# **Moore College Newtown Concept Plan**

## **Strategy for the Provision of Access for People with Disabilities**

**October 2009**

**Prepared by:  
Access Associates Sydney**

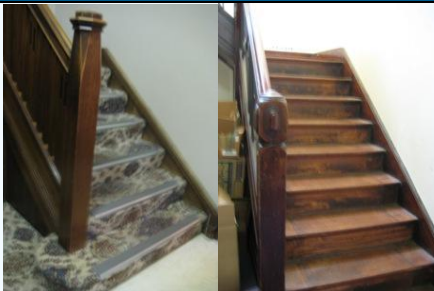
Column 1 Item    Area	Column 2 The current situation	Column 3 Issues	Column 4 Photograph
	<p>The 1700mm wide footpath on the southern side Carillon Avenue between Little Queen Street and the site (B) boundary covers a distance of approximately 90m.</p> <p>The footpath includes the following approximate gradients (G) in the direction of the path of travel and crossfalls (X):</p> <ul style="list-style-type: none"> <li>• Intersection of Carillon Ave &amp; Little Queen Street G=1:13; X=1:60</li> <li>• Carillon Ave approx 14m from Little Queen Street G=1:20; X=1:40</li> <li>• Carillon Ave approx 90m from Little Queen Street G=1:60; X=1:40</li> </ul> <p>A pedestrian crossing links the footpaths on the southern and northern sides of Carillon Avenue near the western site boundary. The northern side of Carillon Avenue includes entrances to the Sydney University campus.</p> <p>Newtown North Public School is located adjacent to the site (B) boundary. Site B includes existing residential buildings for student/family accommodation.</p>	<p>A functional accessible path of travel including unobstructed circulation space and clear wayfinding for people with mobility and vision impairment is generally provided.</p>	 <p>3.2.2b Footpath on the southern side Carillon Avenue between Little Queen Street and site boundary view east.</p>  <p>3.2.2c Pedestrian crossing linking the footpaths on both sides of Carillon Avenue near the western site boundary.</p>
